ADDENDUM

ADDENDUM NO.: 03
PROJECT NAME: Kenwood Academy High School Link and Mechanical Project
PROJECT NO.: 05326
CONTRACT NO.: C1602
DATE OF ISSUE: October 25, 2022

NOTICE OF CHANGES, MODIFICATIONS, OR CLARIFICATIONS TO CONTRACT DOCUMENTS

PBC Project Name: Kenwood Academy Link
PBC Contract No.: C1602
Project No.: 05328
Title: LOGISTICS, PHASING & SITE UTILIZATION PLANS

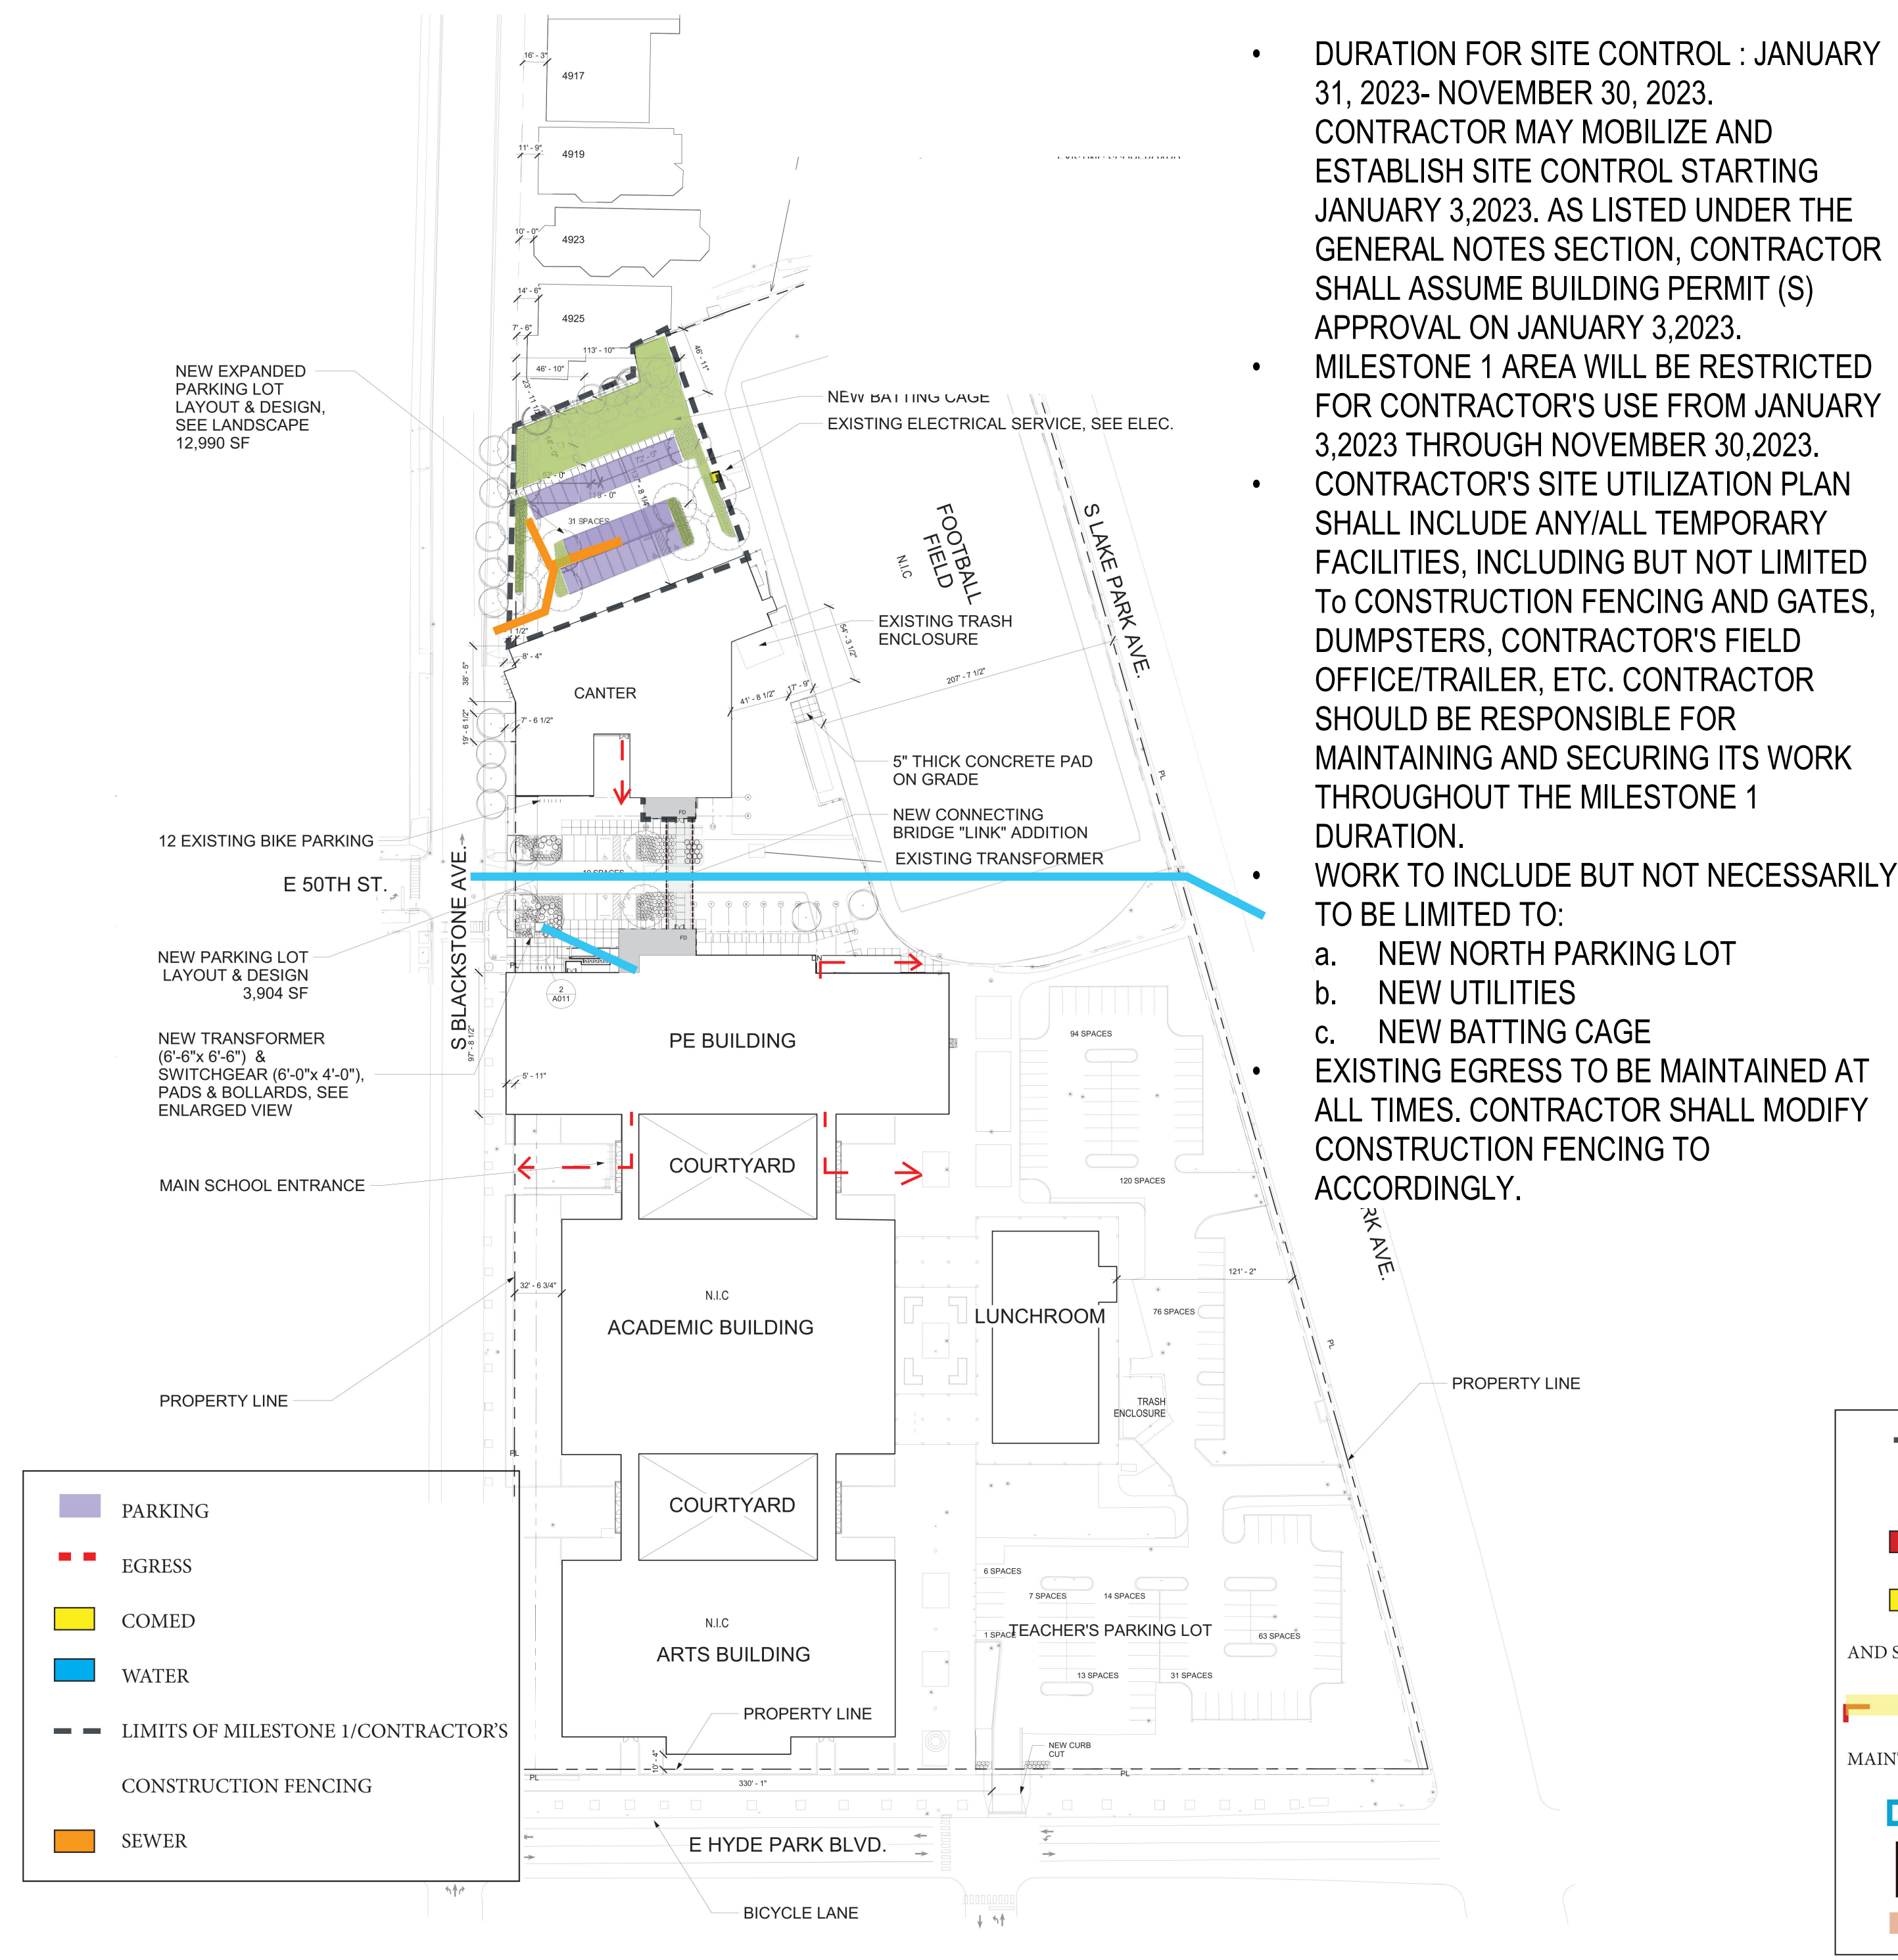
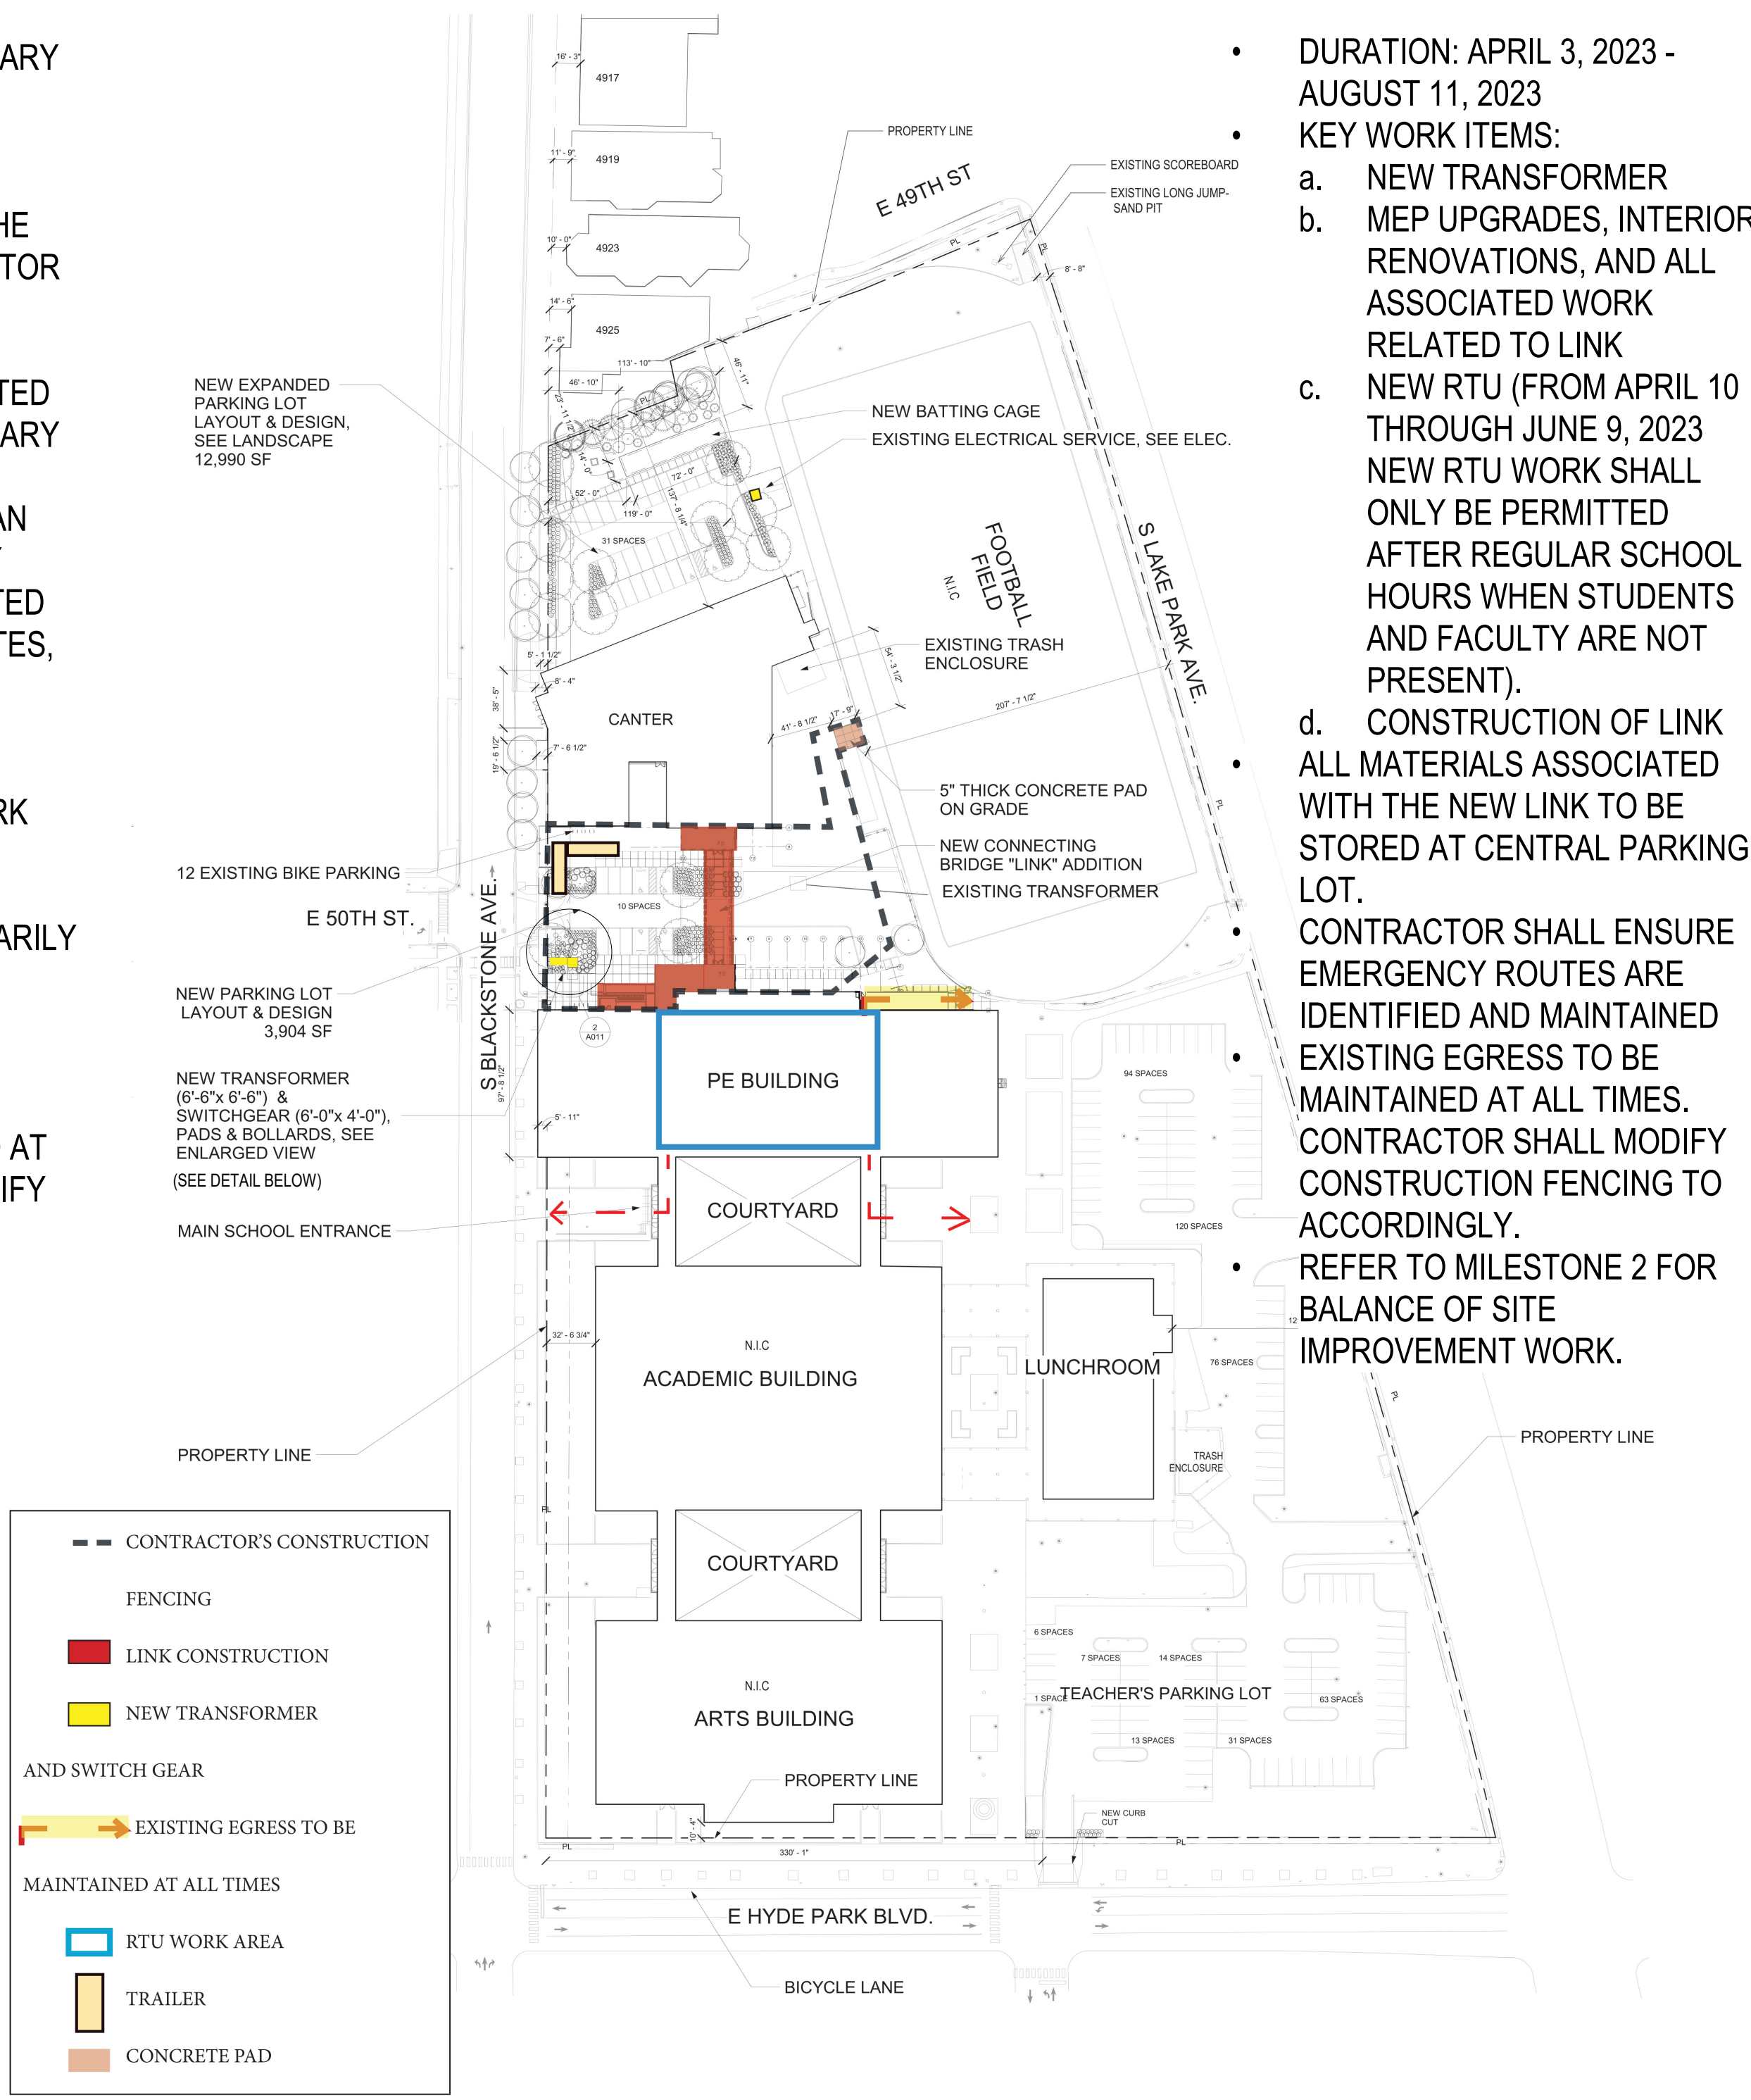
- Question:** The table of Contents in Book 1 for the Link Building lists specification section 01 14 11 Construction Operations and Site Utilization Plan as an included spec section, however this section does not appear in the spec book. Furthermore, the 3rd general note from the top on page G015 of the Link drawings makes reference to this spec section. Please issue specification section 01 14 11 Construction Operations and Site Utilization.
- Response:** Bidders are advised Specification Section 01 14 11, Construction Operations and Site Utilization Plan is stricken, and a revised Sheet G-015 with Specification Section 01 14 11 (third bullet) stricken is included in this Addendum No. 3.
